PLYMOUTH HOUSING
12TH & SPRUCE SUPPORTIVE HOUSING

169 12TH AVE
SEATTLE, WA 98122
SDCI PROJECT # 3032409-LU
DESIGN RECOMMENDATION
MEETING DATE: 04/01/2020

MASSING

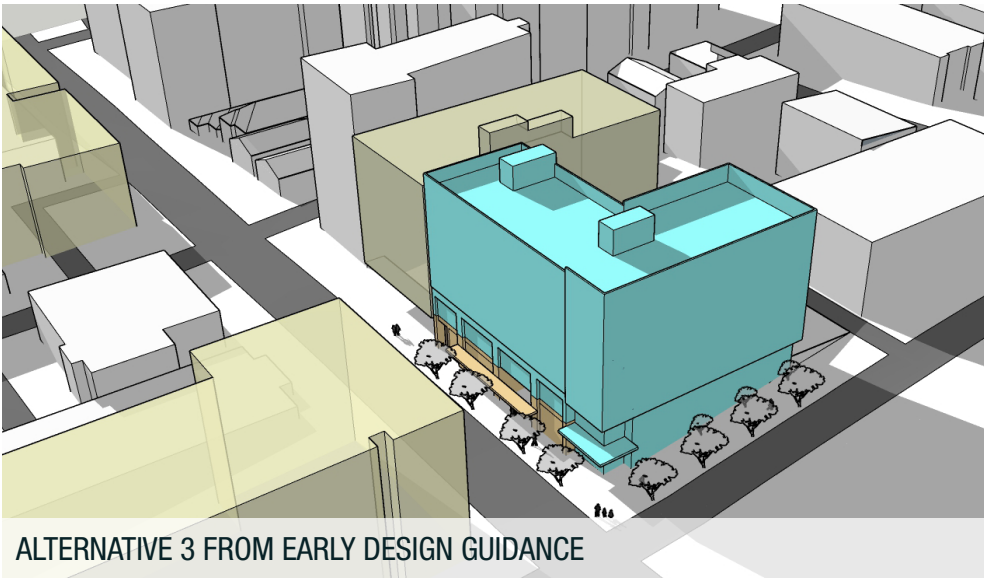
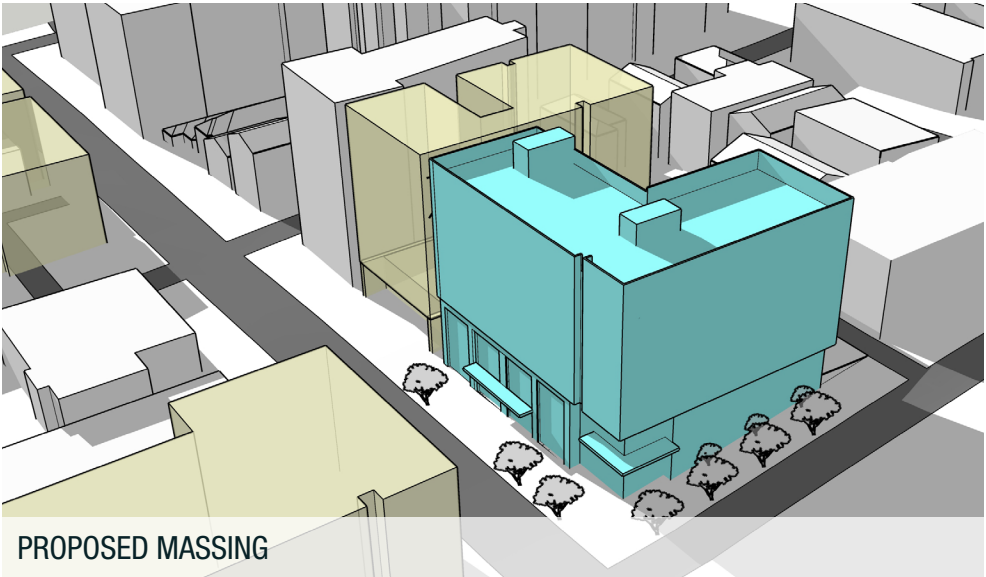
Staff supports further development of the applicant’s preferred massing scheme, Alternative 3. The strong street edge helps the building hold the corner and the relatively simple form allows for a restrained architectural expression that is appropriate for the uses intended and the surrounding context. (CS2-B-2, CS2-C-1, CS3-A, DC2-A)

Alternative 3 was further refined maintaining a corner presence with a restrained architectural expression.

EAST ELEVATION

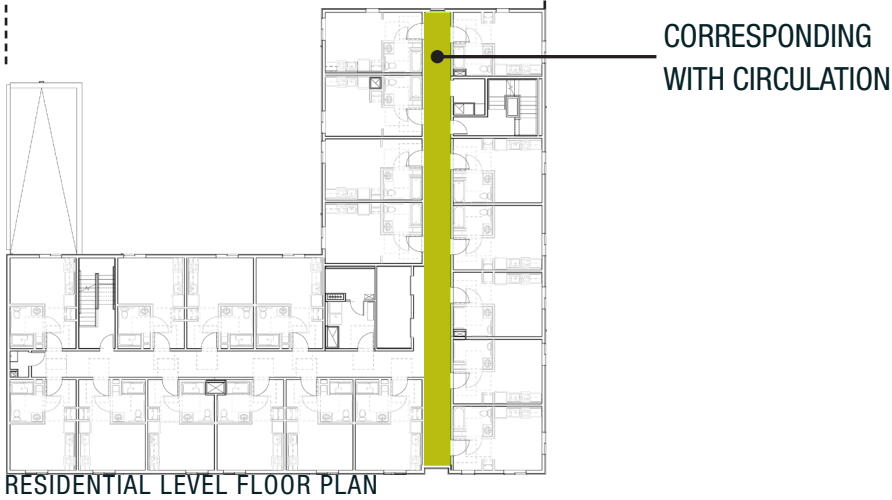
The perspective renderings appear to show the E Spruce Street volume extending proud of the 12th Avenue volume, which is an architecturally interesting form and also functions to mark the location of the residential entry. However, the plan view shows a regular right angle at this location with no change in plane between the two volumes, resulting in a simple L-form with no modulation. Pull the E Spruce Street massing further east to match the modulation suggested in the perspective renderings and/or introduce a gasket between the two volumes using the internal circulation as a logical place for the break. (CS2-A, CS2-C-1, DC2-A)

A gasket was introduced between the two volumes at the circulation on the residential corridors. The gasket has provided a logical location for the accent color to break the two masses.

TWO STORY BASE

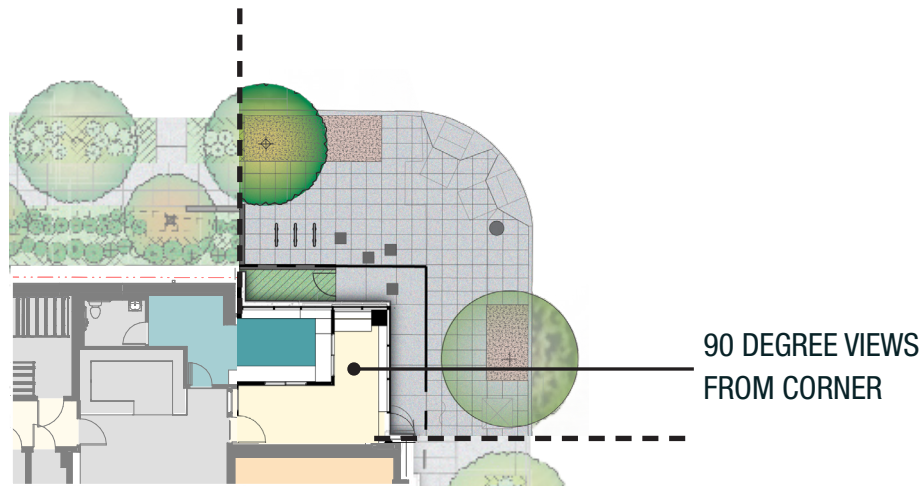
Staff supports the two-story base which creates an attractive proportional relationship with the massing above. Retain this relationship in the MUP plan set. (DC2-A, DC2-B-1, DC2-D-1)

The two-story base/proportion was retained and further defined with material and color selection.

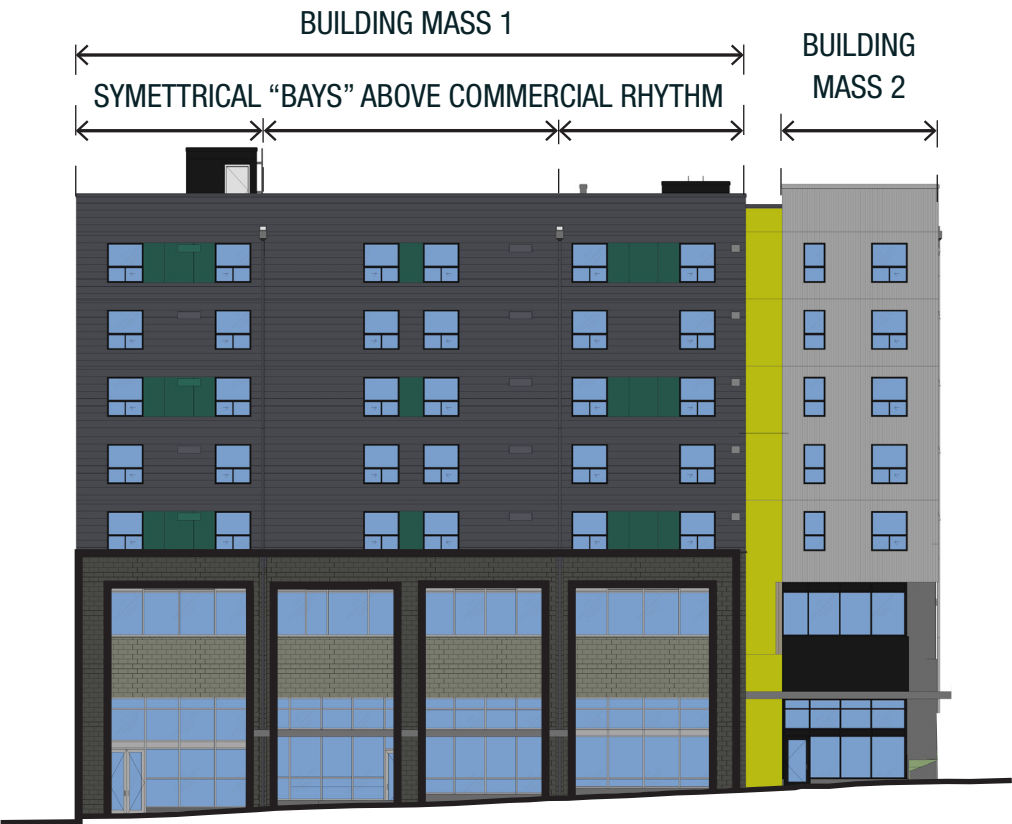
Staff notes the relative simplicity of the massing and supports a restrained architectural expression. Quality materials and attention to detailing will be essential to the success of the design. Choose materials that are durable, appropriate for Seattle’s climate, and visually interesting. Look for opportunities to integrate subtle details that enhance the building’s simple form. (CS2-C-1, DC2-B-1, DC4-A, DC4-2, DC4-3)

The restrained architectural expression was maintained with added detail elements such as the gasket separating the two volumes as well as color accents between windows along 12th Avenue. The volume along Spruce Street remained restrained to allow the extensive planting and tree canopy to be highlighted and transition to the MR zone with minimal impacts. The main material for the two-volumes is metal siding which is durable and appropriate for this climate. Two different profiles and orientation have been selected to distinguish the volumes. Fiber cement siding was selected at the gasket and color accents to allow for custom colors. Between the residential windows, the fiber cement is a shallower depth which will allow for a recessed window look effect. The windows will also be recessed from the exterior wall plane to increase the shadow. The pedestrian level façade is proposed to be a concrete masonry unit block with a smooth texture which is a very durable material.

CANOPY RAIN SHADOW AT CURRENT DESIGN

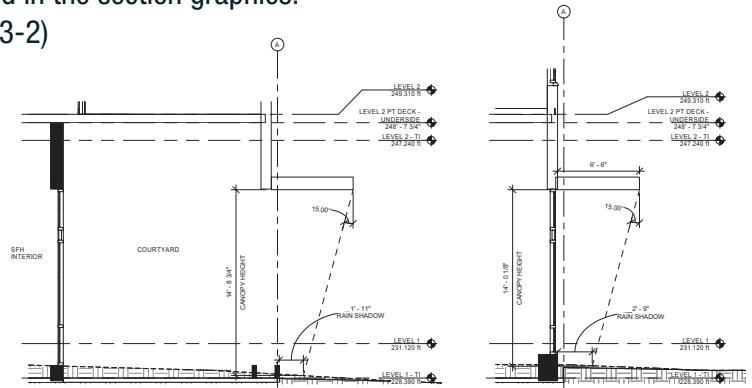
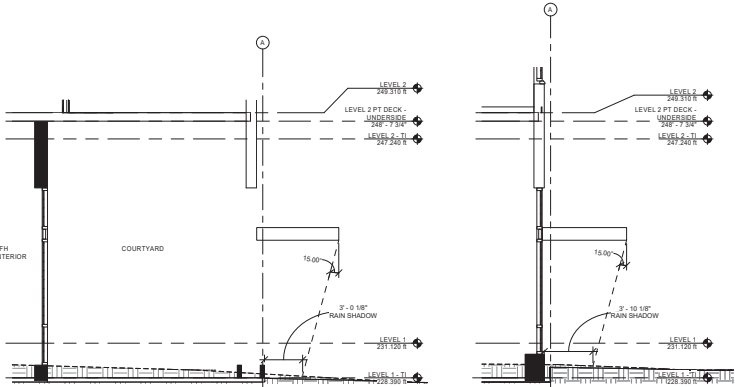
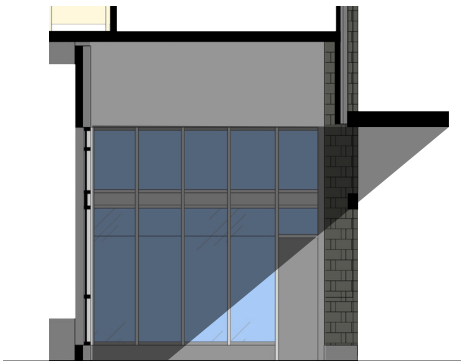
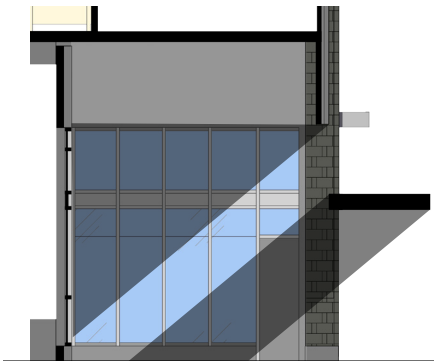
Staff supports the use of canopies to further differentiate the residential and commercial uses. However, the proposed height of the commercial canopies along 12th Avenue block views of the transom windows which are an attractive and visually interesting aspect of the street level experience. Raise the canopy height above all ground floor glazing and use other architectural details (such as depth, color, materials, or soffit treatment) to help further differentiate the uses. (CS3-1, PL2-C, PL3-A, PL3-1)

While we initially responded to this request, further design exploration discovered the height of the canopy would eliminate direct natural light into the interior spaces and, more critically, exterior courtyard. Additionally, the height of the raised canopy would eliminate any meaningful weather protection for the pedestrian. With the lower canopy height there is an approximate rain shadow width between 3'-0" to 3'-10", as opposed to the higher canopy height's approximate rain shadow width of 1'-11" to 2'-9". The canopy at the lower/zoning compliant height also respects the human scale. The raised canopy to the top over-scales the pedestrian as represented in the section graphics. (PL2-C, PL3-2)

EXTERIOR AND INTERIOR CONNECTION

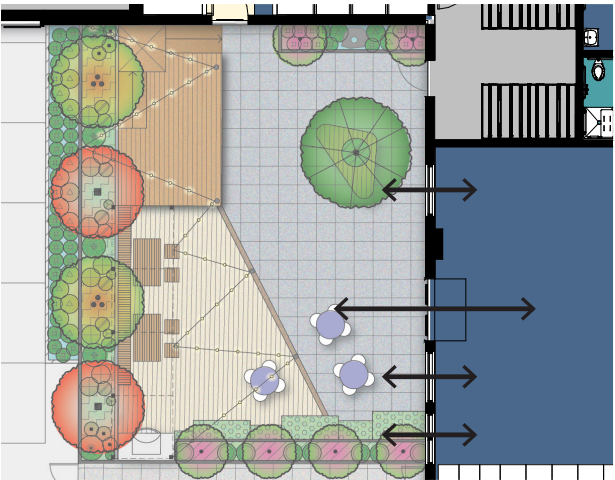
Staff supports the relationship between the interior and exterior residential amenity areas. The adjacent location and double doors create a more natural flow between the two spaces and allow for a greater variety of uses and activities. Retain this arrangement in the MUP plan set and use glazing, materials, and programming to further enhance this relationship. (DC4-2-a)

The connection between the interior and exterior amenity space has been maintained. Windows and a double door provided connection and access between the two spaces.
